**BEFORE THE PUBLIC UTILITY COMMISSION
OF OREGON**

LC 63

In the Matter of)
)
IDAHO POWER COMPANY)
)
2015 Integrated Resource Plan)

**OPENING COMMENTS OF THE
CITIZENS' UTILITY BOARD OF OREGON**

Figure 1 – Idaho Power’s EE Under Forecasting²

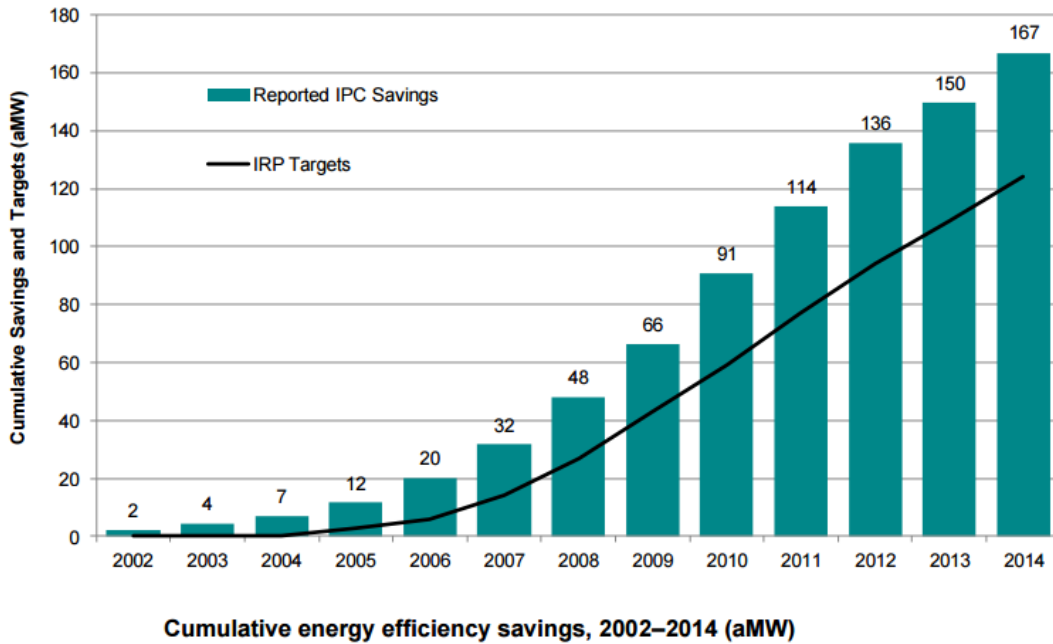
1 indication that the study corrects or addresses Idaho Power’s systematic under forecasting
2 of its EE targets. As a demonstration of this, see the graph below:

3 Eyeballing the graph reveals that Idaho Power consistently overshoots its EE
4 goals every year, and the gap between projected and actual EE only seems to increase
5 over time. 2014 seems to carry the largest gap at roughly 47 aMW—about 411,720
6 MWh.³ While CUB is pleased that the Company has managed to meet its EE targets so
7 successfully, CUB wishes to flag these results as an important indicator of why the
8 Company should reconsider its approach to EE assumptions in the IRP process.
9 Ultimately, the less the Company relies on energy efficiency, the more it will rely on
10 supply-side resources, and the more this will cost ratepayers.

Figure 2 – NWPCC EE Projections¹⁰

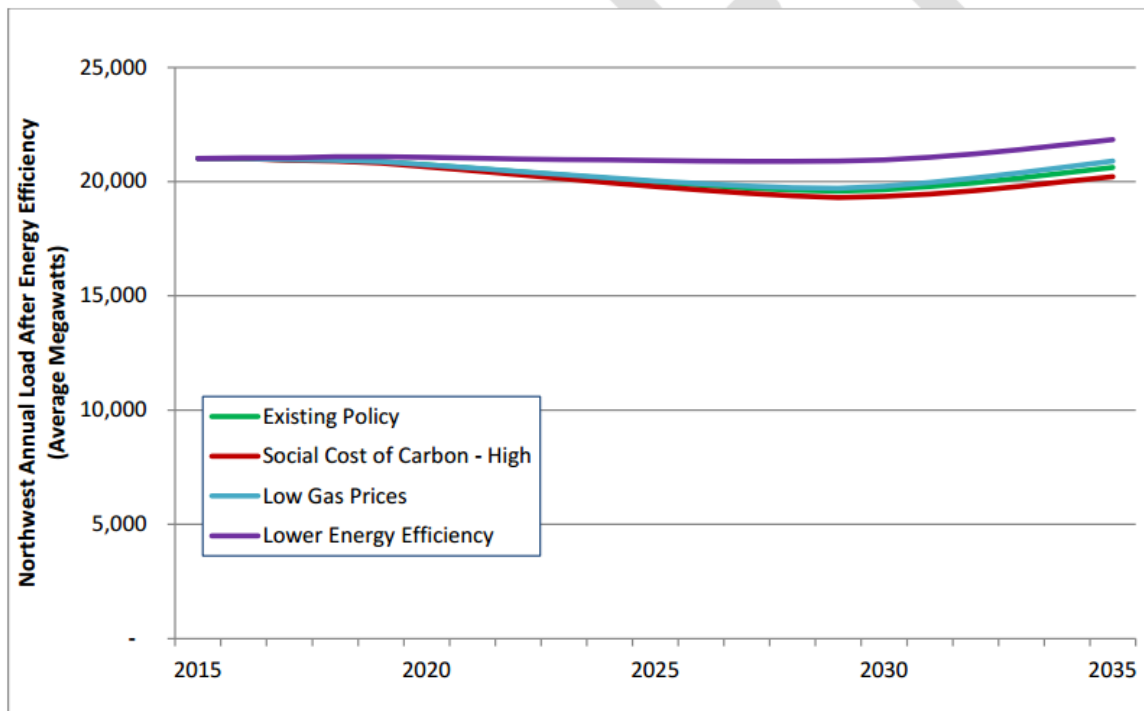
3 The draft of the 7th Northwest Power Plan states that energy efficiency can
4 potentially meet 90% of all electricity load growth through 2035. This incorporates the
5 entire Northwest region, which includes Idaho Power's service territory. NWPCC's study
6 considered 800 energy futures, and even with lower-than-expected gas and electric
7 prices, and under low carbon risk scenarios, 90% of the cases modeled were still able to
8 meet load growth through energy efficiency.⁹ The graph below is from NWPCC's draft
9 report:

1 The graph above accounts for cost-effective EE for average net regional load, and
2 this includes a variety of scenarios, including low gas prices and low EE scenarios. Load
3 throughout the planning period actually decreases at some point but initially stays flat and
4 does not increase past 2015 levels for at least 20 years.

5 That Idaho Power is projecting a need for a new CCCT plant every five years is
6 baffling to CUB. CUB understands that neither Idaho Power's nor NWPCC's projections
7 will be 100% accurate. But surely, some middle ground can be reached between the
8 Company's static, under forecasted "achievable" energy efficiency and NWPCC's
9 projections about how EE can be used to meet 100% of load growth. A new approach to
10 energy efficiency could save ratepayers hundreds of millions of dollars.

Figure 3 – Idaho Power’s DR Under forecasting¹²

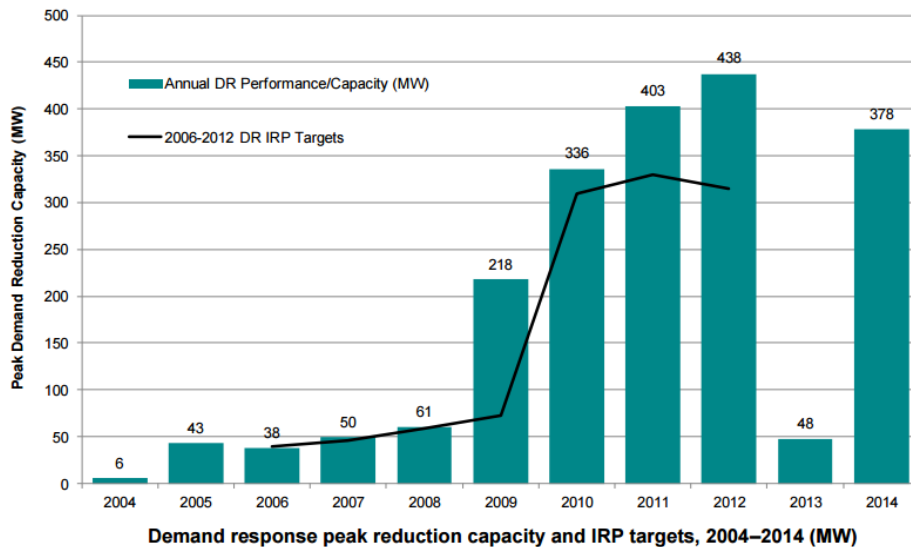
1 While demand response is not directly comparable to energy efficiency, it is
2 arguably a program over which the Company has even more control. As the graph
3 demonstrates, peak demand reduction increases year by year, with the exception being in
4 2013 when some demand response was temporarily suspended “to address need and cost”
5 of the Irrigation Peak Rewards program.¹³ The Company notes in its IRP that 91% of the
6 same participants from 2013 participated in the program after it was reinstated, despite
7 the incentives in the program being reduced.¹⁴

8 CUB understands that the Company is required to pursue least-cost/least-risk
9 programs, but if the Company is willing to put five more CCCT turbines on the table in
10 the next 20 years, CUB asks that the Company lend more weight to demand-side
11 resources so that both resource types (supply and demand side) are given equal treatment.

Figure 9.10 LOLE (hours per year)

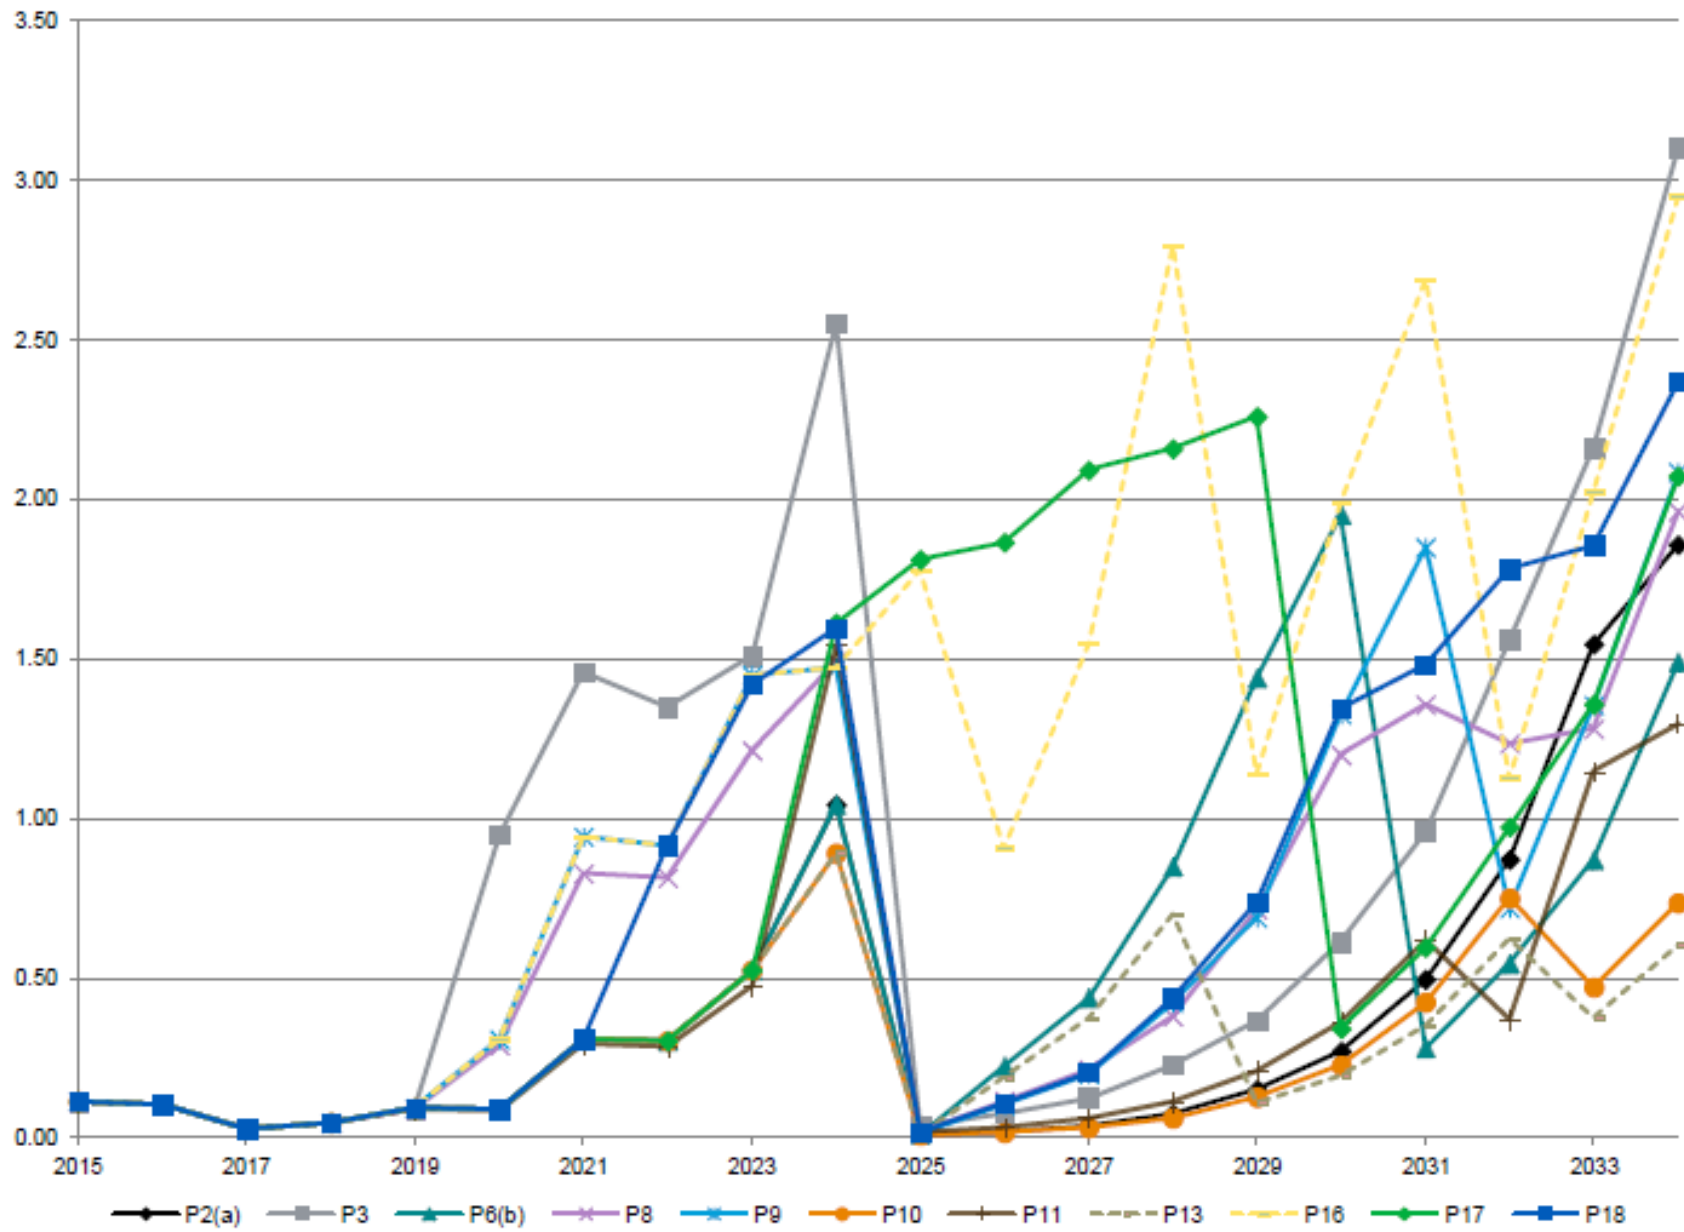
18 In addition to these cost comparisons, Portfolio 6(b) does not seem to be very
19 different from its lower-cost counterparts in terms of risk. Figure 9.10 in the IRP depicts
20 LOLE probability analysis results, and portfolios 6(b), 8, 9, and 11 all fall under the 2-

²⁵ Curiously, on page 139, the Company excludes Portfolio 9 from the list of portfolios that operate with an LOLE of less than two, but a close look at Figure 9.10 on page 140 clearly shows that Portfolio 9 also falls within this low-risk projection.

1 hour LOLE threshold.²⁷ Why is the Company choosing a Portfolio that does not meet
2 least-cost/least-risk requirements?
